ORIGINAL
NUCLEAR REGULATORY COMMISSION

ADVISORY COMMITTEE ON REACTOR SAFEGUARDS
SUBCOMMITTEE ON FLUID DYNAMICS

DATE: September 25, 1981 PAGES: 168 thru 202

MONTE CARLO SIMULATION SHOWS LARGE MARGIN RELATIVE TO DESIGN FOR SYMMETRIC LOAD CASE. (GLOBAL LOADS).

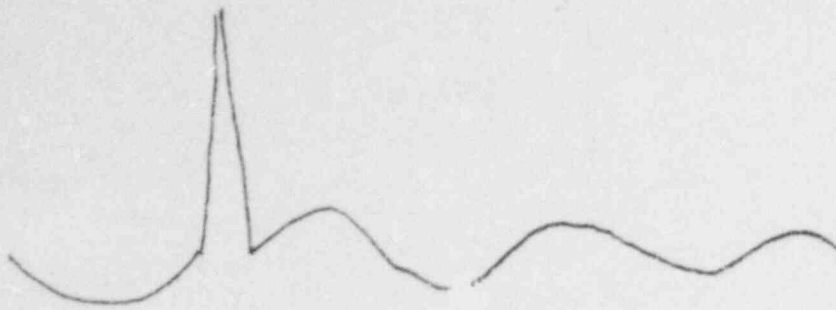
SOME CONCERNS:

WEIR WALL EXCEEDANCE (30-40 Hz).

ABSENCE OF ASYMMETRIC CHUGGING LOAD.

ASYMMETRIC CHUGGING LOADS IMPLIED BY MONTE CARLO SIMULATION MAY BE BOUNDED BY ASYMMETRIC POOL SWELL LOAD.

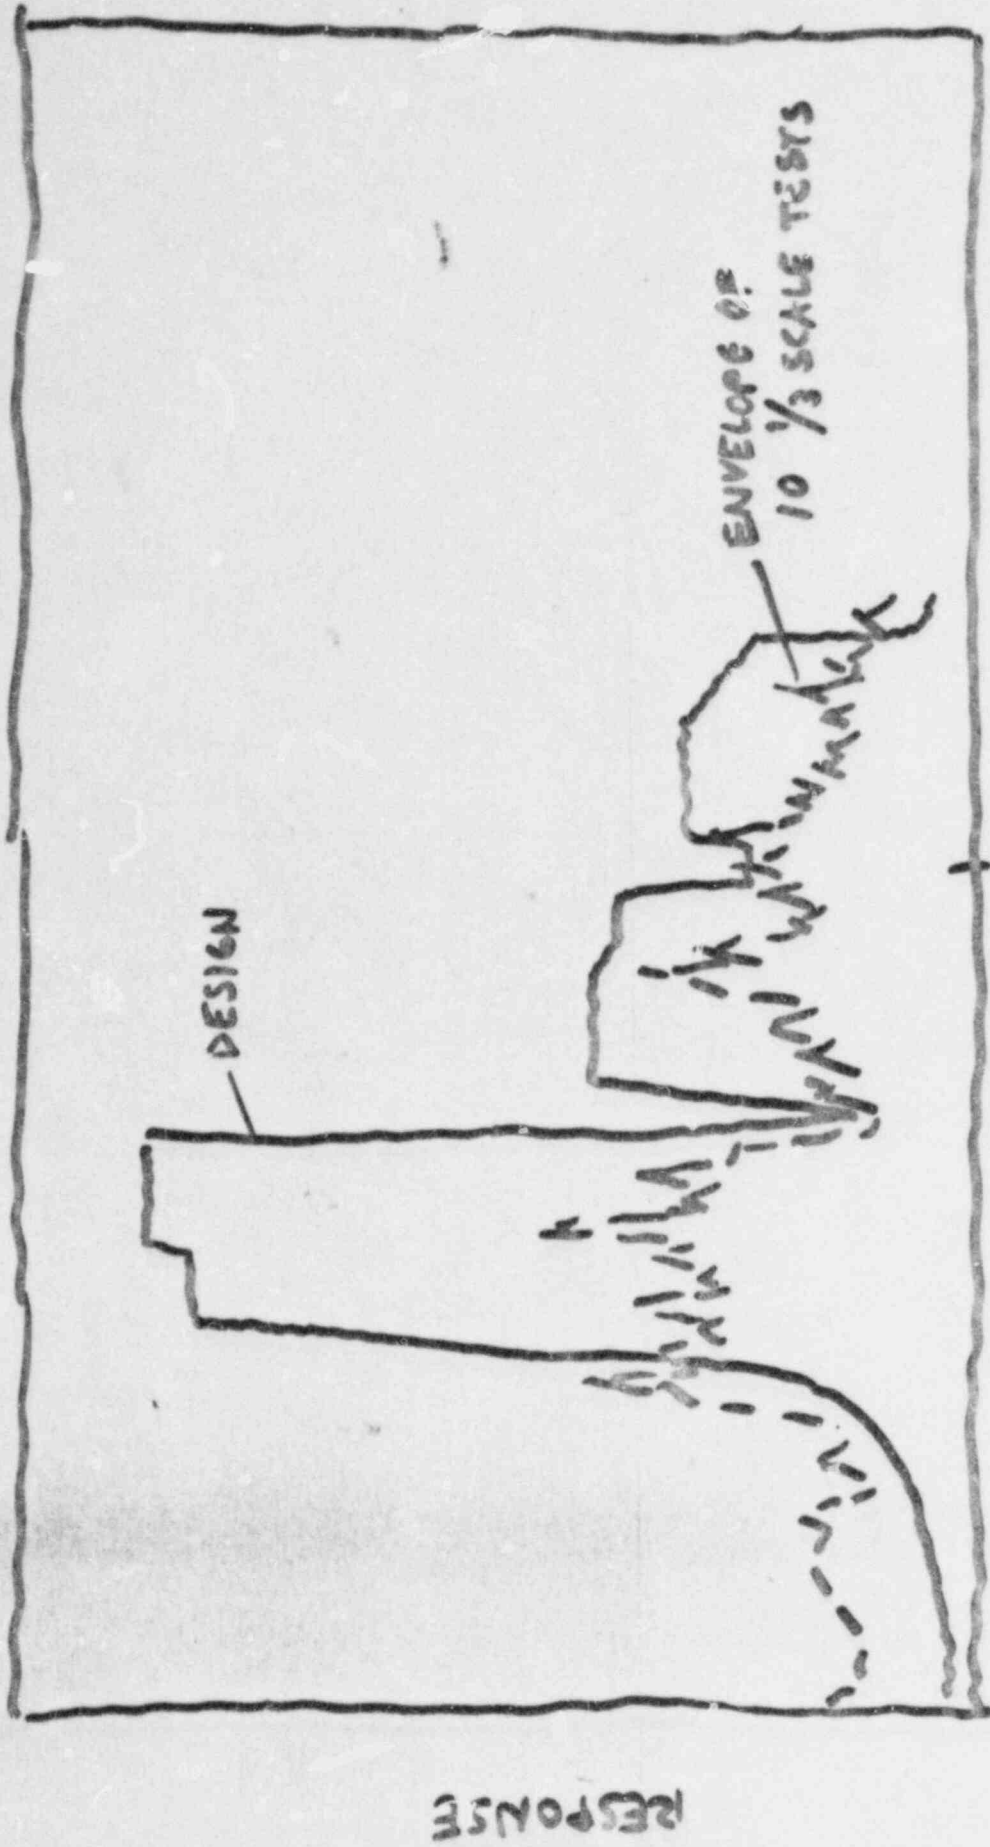
- .. APPLICABILITY OF $\frac{1}{3}$ AREA SCALE TESTS FOR PROTOTYPE (SCALING LAWS)
- .. BOUNDING OF ALL MEASUREMENTS
- .. IS DBA "WORST" CASE?

- .. APPLY METHODOLOGY AND GENERATE PREDICTIONS FOR $\frac{1}{9}$, $\frac{1}{3}$, FULL SCALE TESTS
- .. COMPARE WITH ALL AVAILABLE MEASUREMENTS
 - ... TIME (PPA, RMS, F) AND FREQUENCY (ARS) DOMAINS
- .. DEMONSTRATE BOUNDING OF ALL DATA
- .. DEMONSTRATE CORRECT PREDICTION OF ALL TRENDS WITH SCALE
- .. APPLY METHOD PARAMETRICALLY WITH VARIATIONS IN PLANT INITIAL CONDITIONS (C_A , T_P) AND BREAK SIZE TO SHOW STANDARD DBA IS WORST CASE

CO LOAD METHODOLOGY

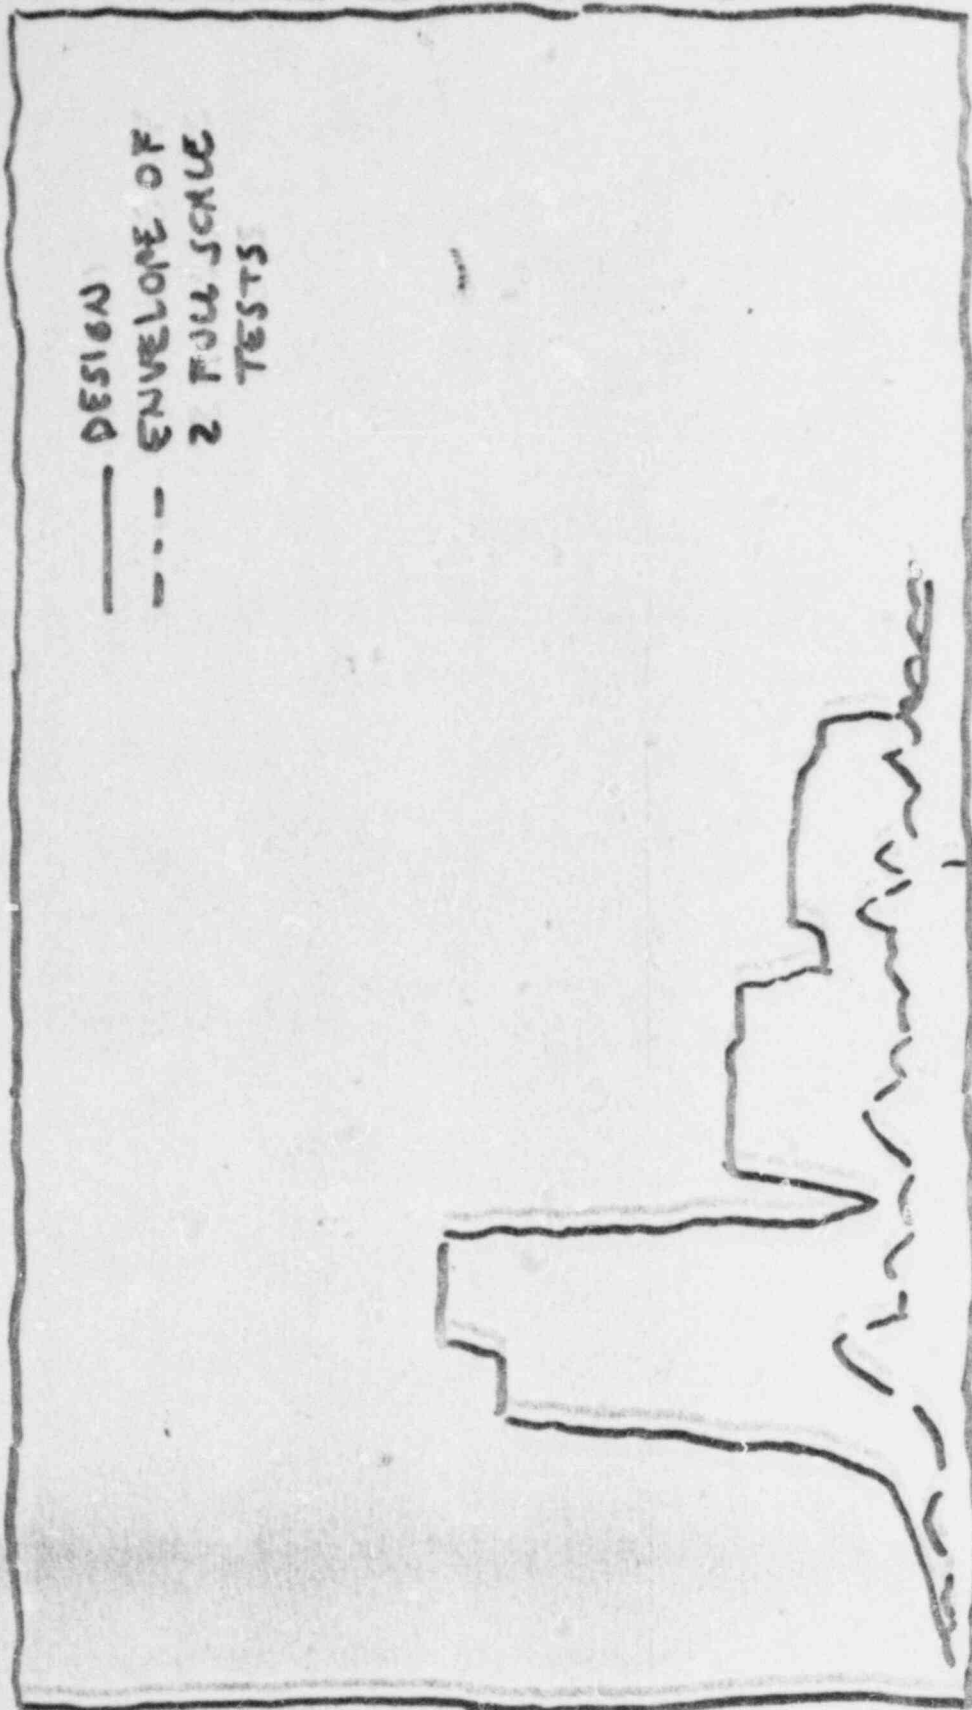
- CONCERN: LACK OF COMPLETE SET OF FULL SCALE TEST RESULTS
- RESOLUTION: ADDED CONSERVATISMS
 - THREE HARMONICS
 - AMPLIFIED ENERGY CONTENT
 - DEMONSTRATED MARGINS

CO LOAD METHODOLOGY

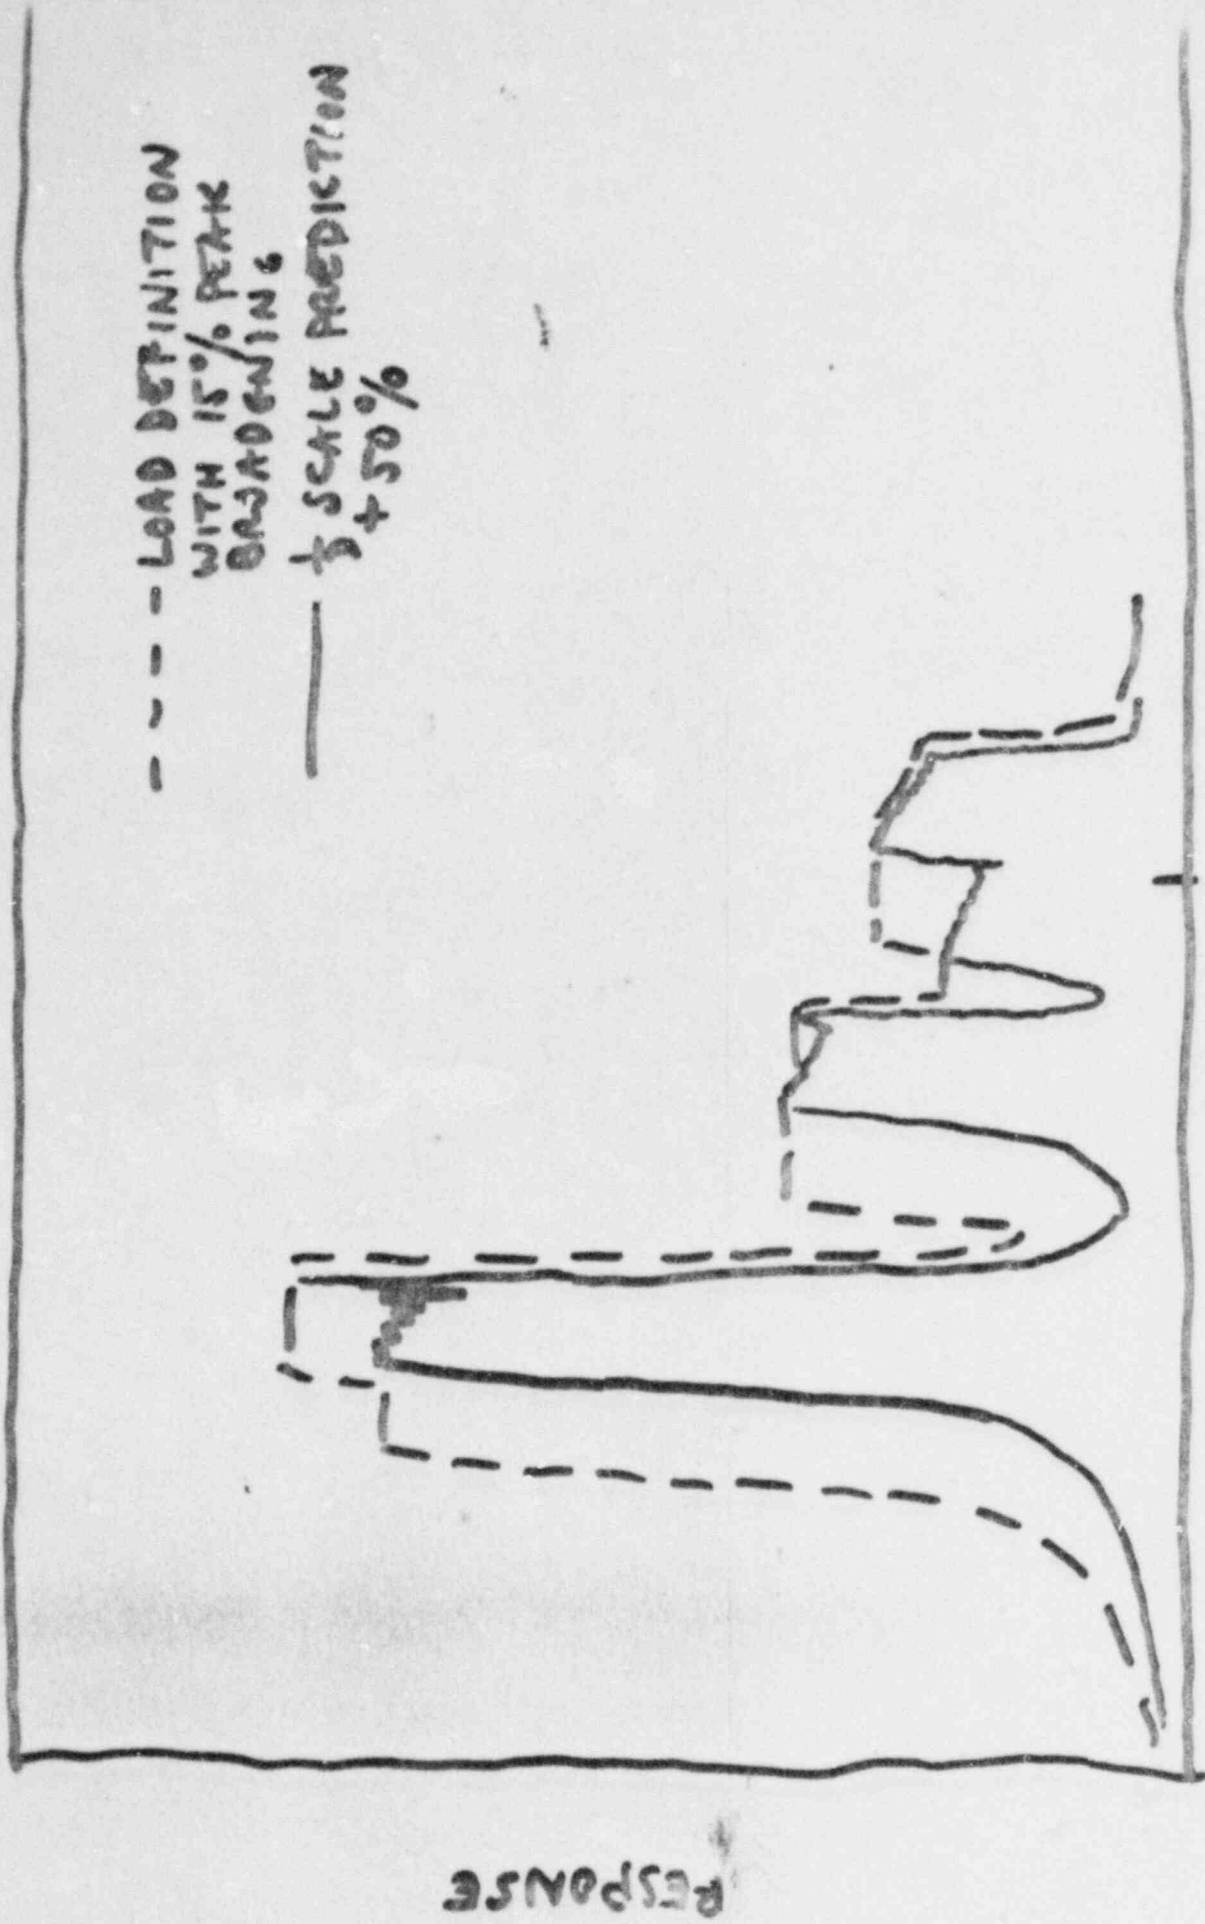
- CONCERN: UNCERTAINTY IN SOURCE FREQUENCY SCALING
- POTENTIAL RESOLUTION (IN PROGRESS)
 - .. CO LOAD DEFINITION ARS WITH 15% PEAK BROADENING BOUNDS SCALING PREDICTION WITH 50% UNCERTAINTY
 - .. PEAK BROADENING DICTATED BY REGULATORY GUIDE
 - .. ARGUMENT HAS MERIT ONLY IF REQUISITE BROADENING IS INTENDED TO BOUND UNCERTAINTY IN FORCING FUNCTION

TWO VENTS:

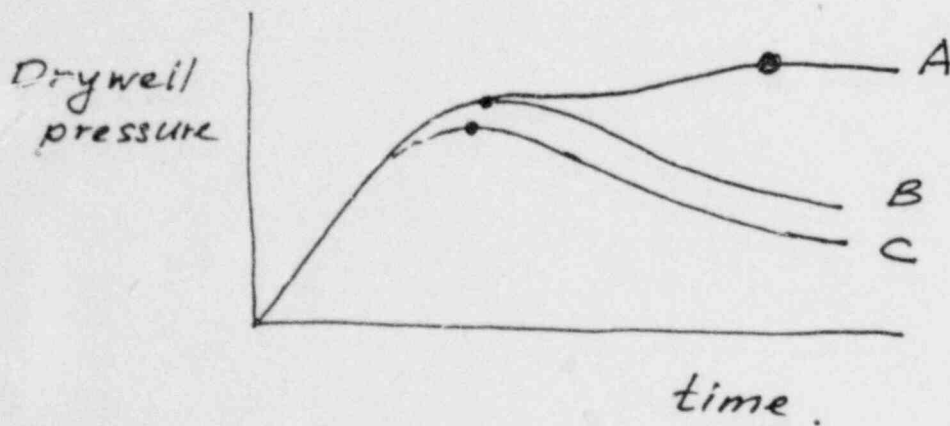
- One vent tests produced half the pool swell velocity of two-vent tests.
- Hence, two-vent tests may well be lower than three-vent tests (i.e. prototype). By how much?

Figure 3B.3-4. Comparison of 238 Standard Plant and Test 5705-4 Drywell Pressure Histories

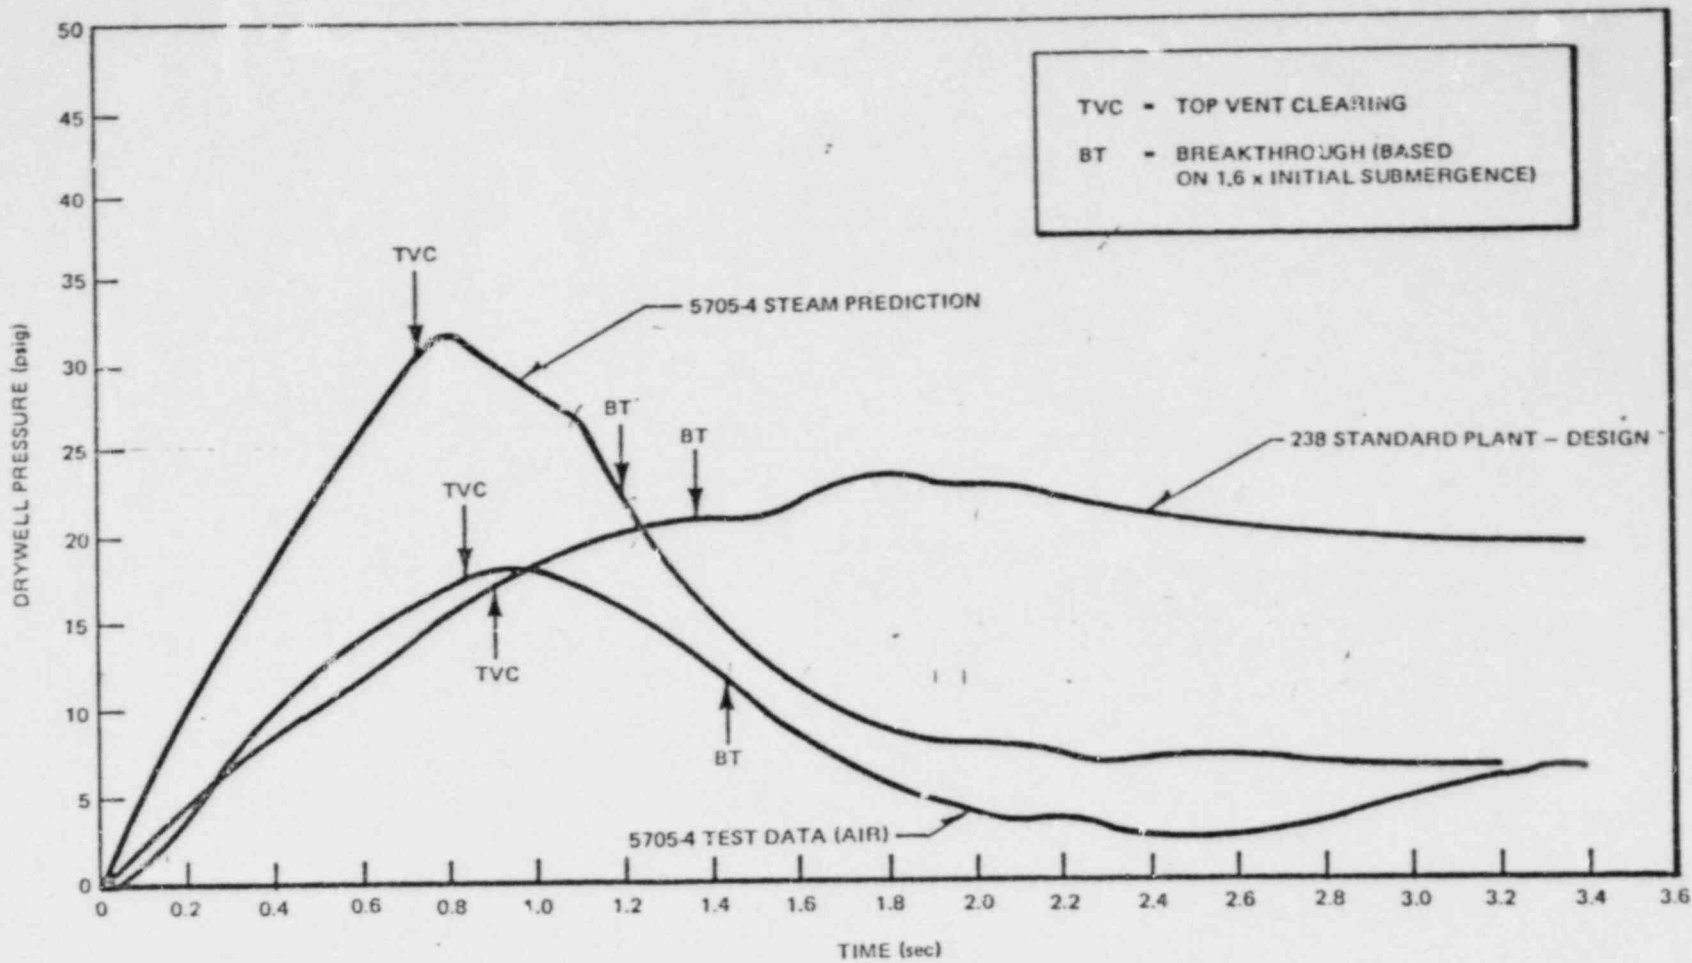
NONCONSERVATIVE DRYWELL PRESSURIZATION

- A. GESSAR DESIGN VALUE 23 psig.
- B. GESSAR PRE-BREAKTHROUGH MODEL 20 psig
- C. G.E.'s "BEST ESTIMATE" 16 psig.

Figure 3B.31(a)-1. LCCA Water Jet Zone of Exclusion

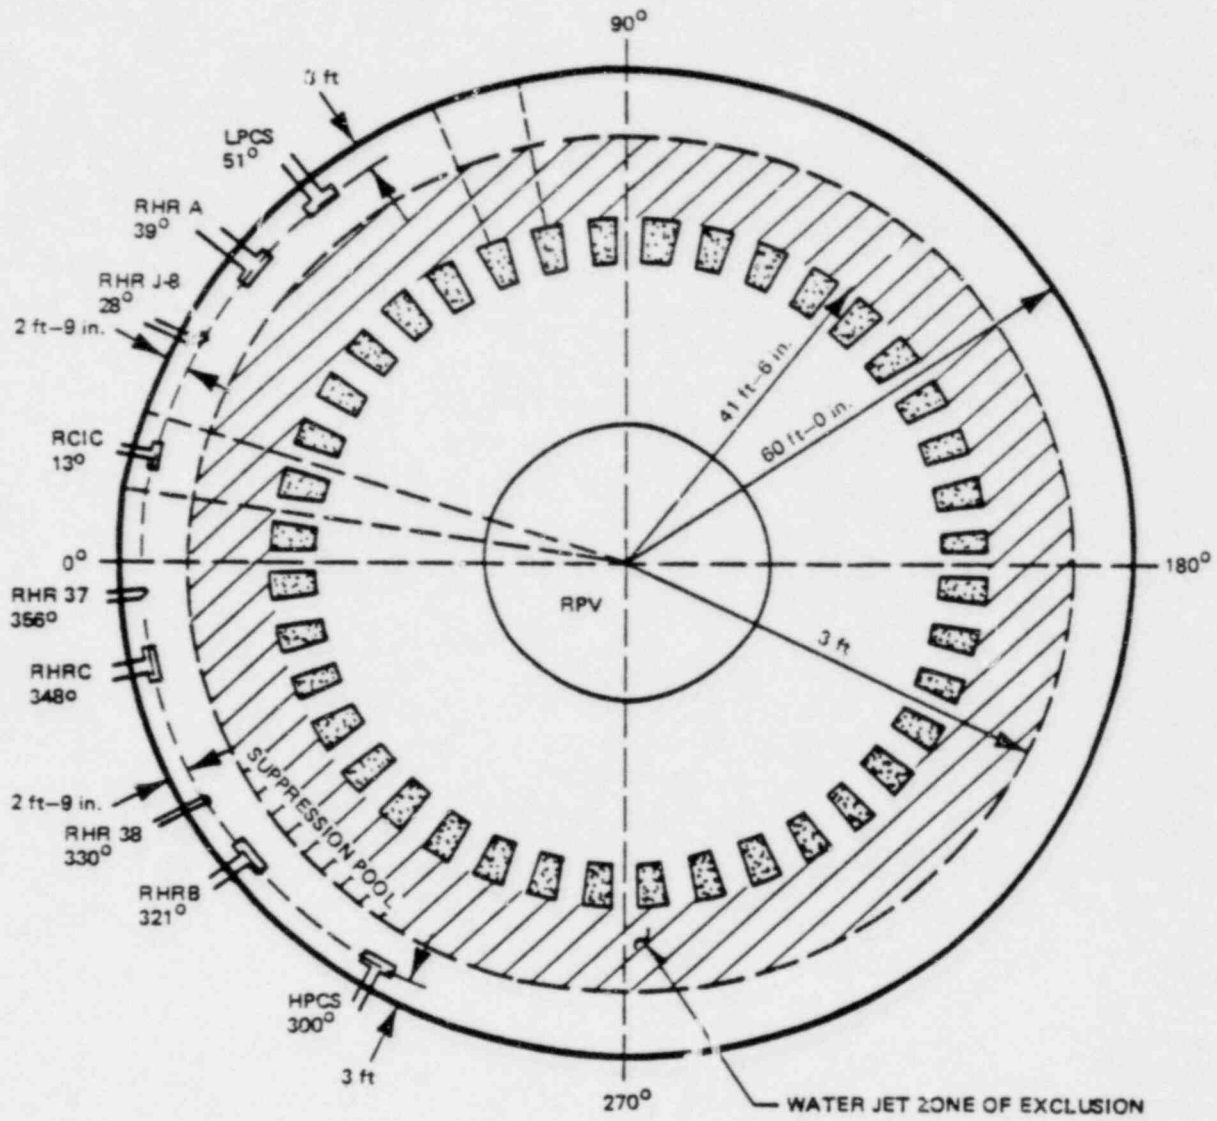
BASIS - EXPERIMENT AND CONSERVATIVE BOUNDS

CONCLUSIONS - NO STRUCTURES IN MARK III FOR WHICH JET LOAD
IS NOT BOUNDED BY BUBBLE LOAD
